Metro Outer Joint Development Assessment Panel Agenda

Meeting Date and Time: Monday, 4 September 2023; 10:00am
Meeting Number: MOJDAP/270
Meeting Venue: Electronic Means

Subject: Response to application seeking Development Approval for a childcare premises at Lot 194 and 193 (No.4 and 6) Malibu Road, Safety Bay.

That the Metro Outer Joint Development Assessment Panel resolve to **REFUSE** Development Application reference DAP/23/02487 and the amended plans and supporting information received on 10 July 2023:

LOTS 194 & 193
TOTAL LOT
AREA = 1453m²

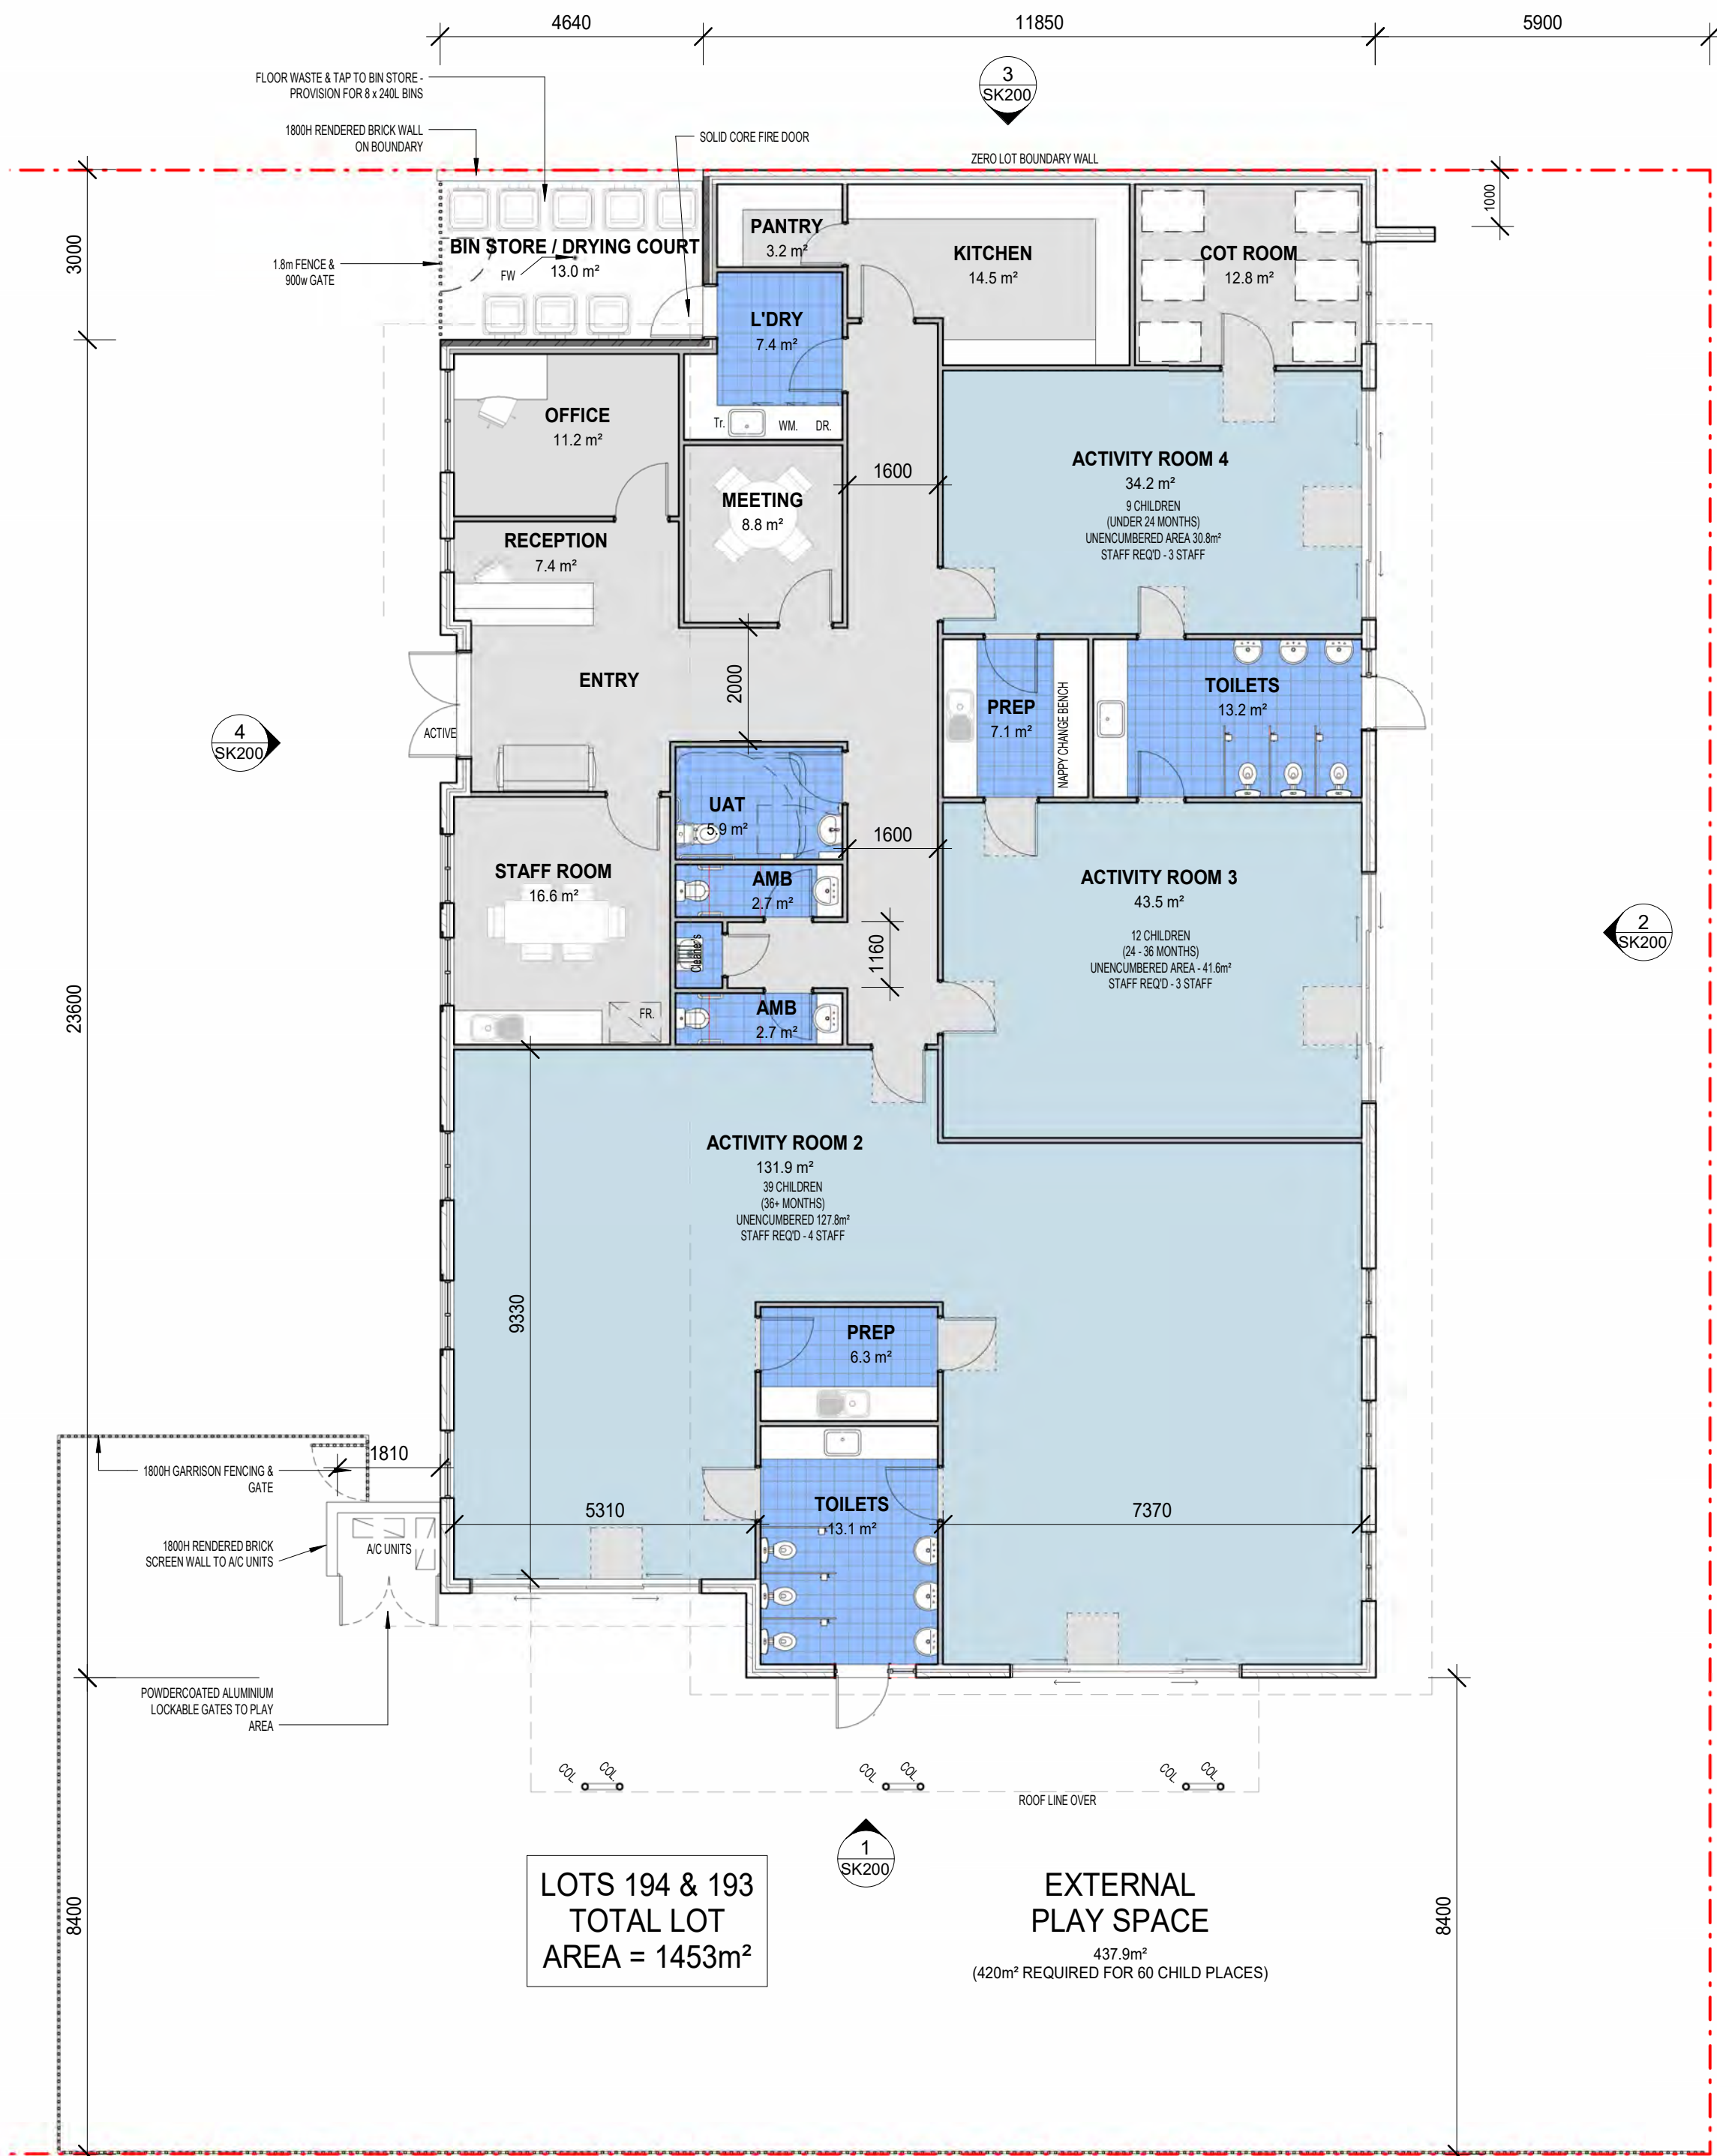
By “flipping” the design, the particulars of the proposed development, such as noise generation, traffic generation, parking requirements, operating hours, number of children and staff, etc. will not change. As a result, the findings of the traffic report are unchanged. In relation to the access location, we acknowledge that the crossover will move closer to the Safety Bay Road and Malibu Road intersection. However, the preliminary advice from the traffic engineer is that this an acceptable outcome. The findings of the EIA will improve.

To address the City's third reason for recommending refusal and to meet the relevant deemed-to-comply requirements outlined in State Planning Policy 7.3 – Residential Design Codes (**the R-Codes**), the following amendments to the Development Plans have been made:

As a result of these amendments to the Development Plans, the proposed development now satisfies the 'Lot boundary setback' deemed-to-comply requirements outlined in SPP 7.3. Therefore, the proposed development now presents an acceptable level of impact to the adjoining residential property situated to the west of the subject site, with respect to the height of the rear boundary wall.

Conclusion:

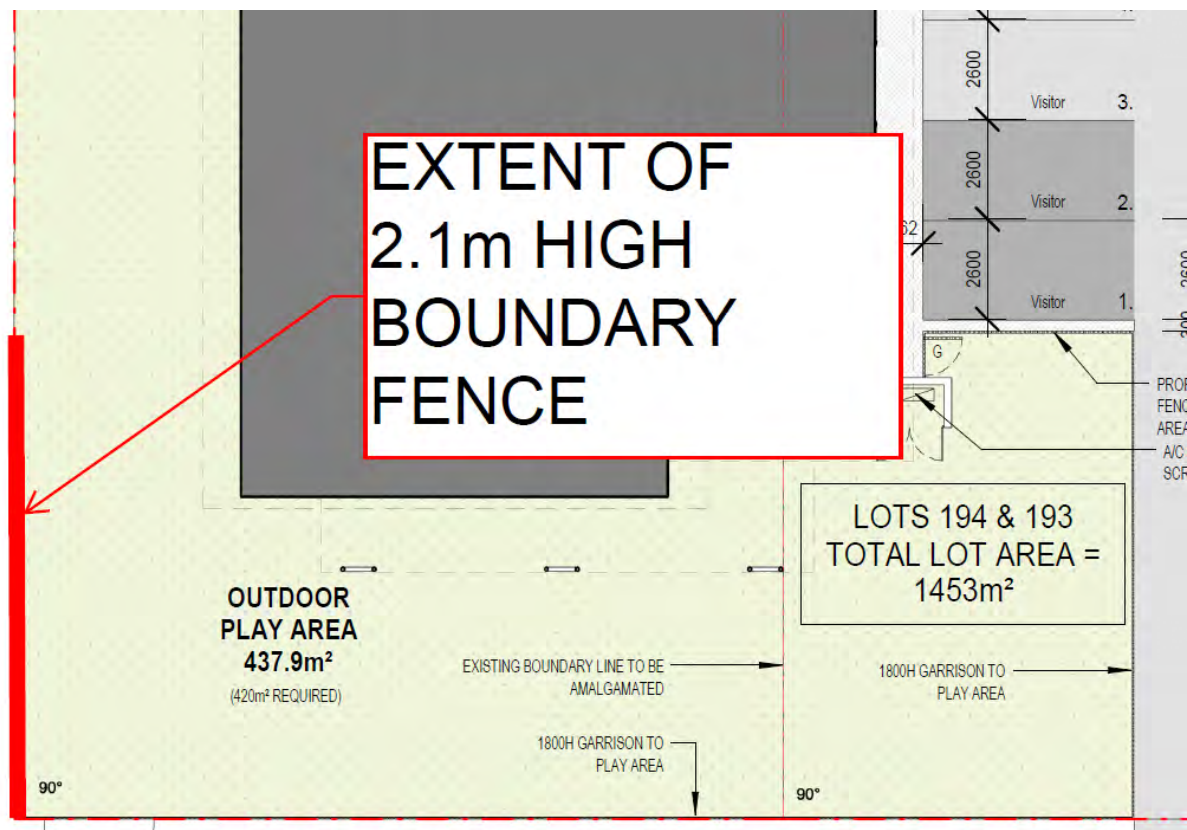
Neighbouring Premises	Calculated Noise Level (dB(A))
South West	49
North East	46
North West	41

Based on the above, it is possible that noise received at the neighbouring residence to the south west, with the IF being only +3 dB rather than +4 dB, could exceed the assigned noise level by 1 dB(A). Thus, to ensure compliance, it is recommended that the boundary fence, as shown below in Figure 01, be 2.1 metre high. With this height boundary fence, the noise received at the neighbouring residence to the south west has been calculated to be 47 dB(A), which complies with the assigned noise level.

FIGURE 03 – NOISE CONTOUR PLOT FOR CAR DOORS CLOSING (DAY PERIOD)

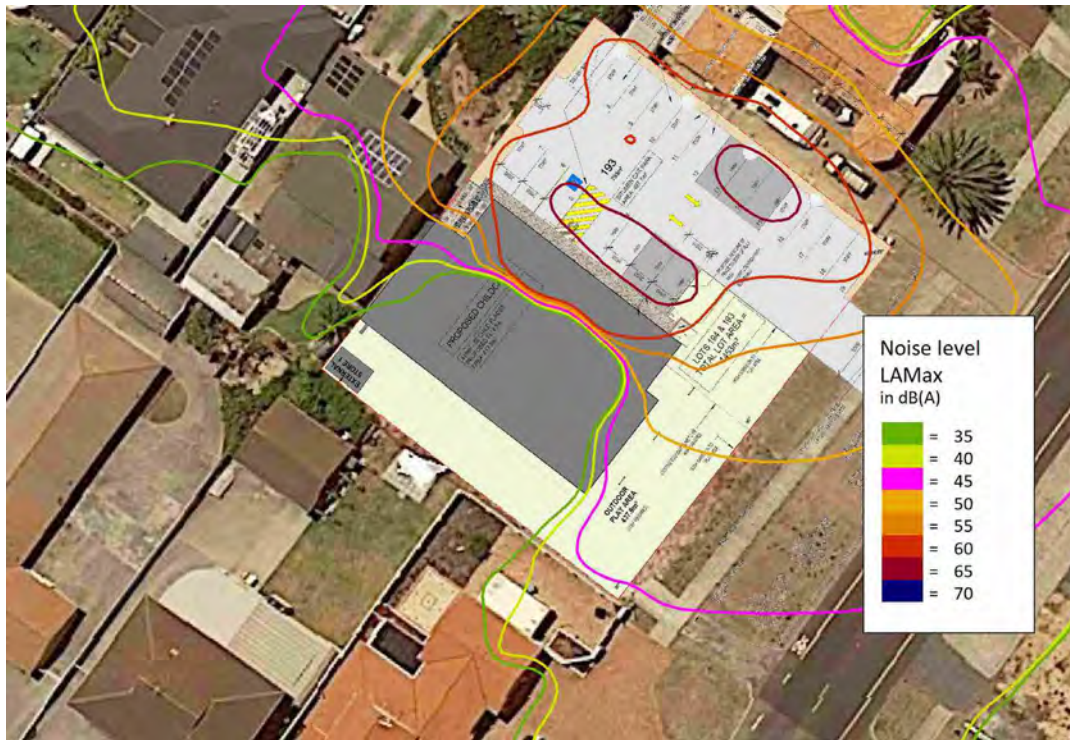
As requested, noise contour plots are provided with regards to the car door closing and the restrictions during the night period.

Figure 03 is for the day period, with Figure 04 being for the night period.

FIGURE 05 – NIGHT PERIOD PARKING RESTRICTIONS

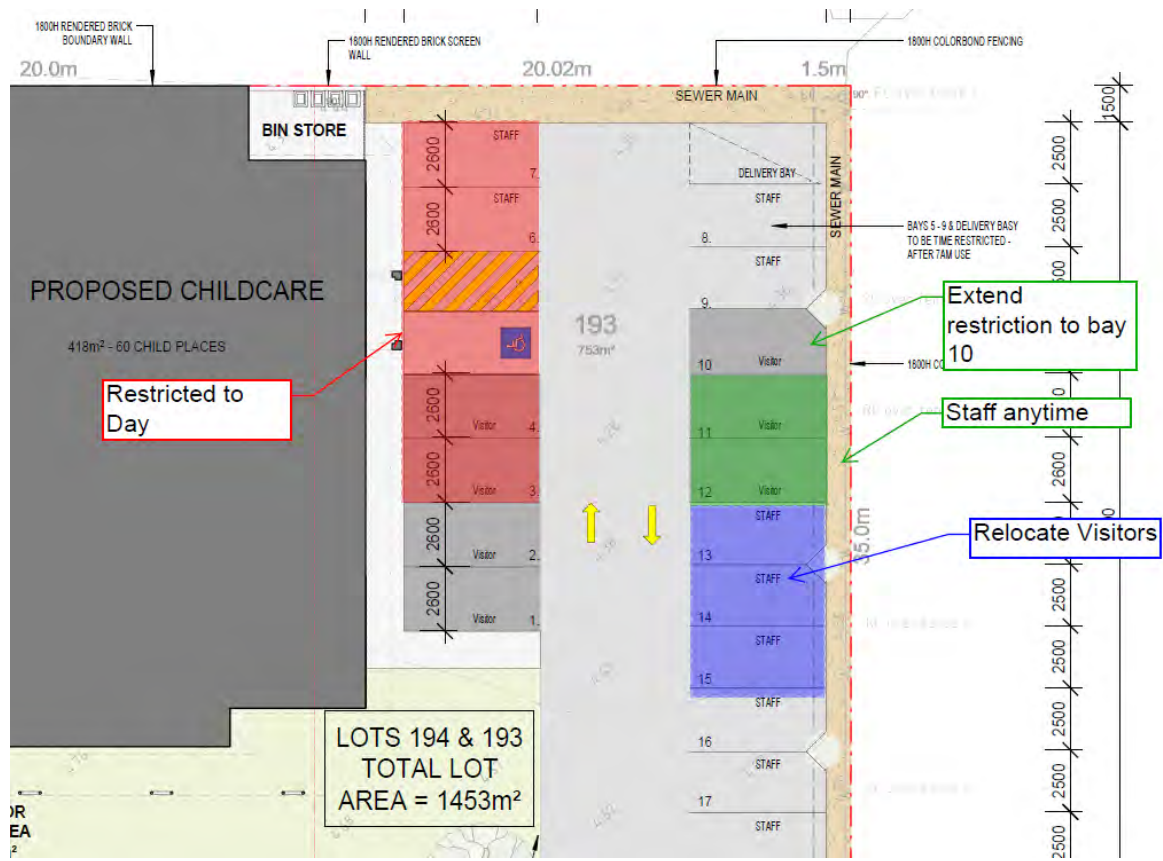
We believe that there may have been some confusion with regards to the night period parking restrictions. Thus Figure 05 is provided.
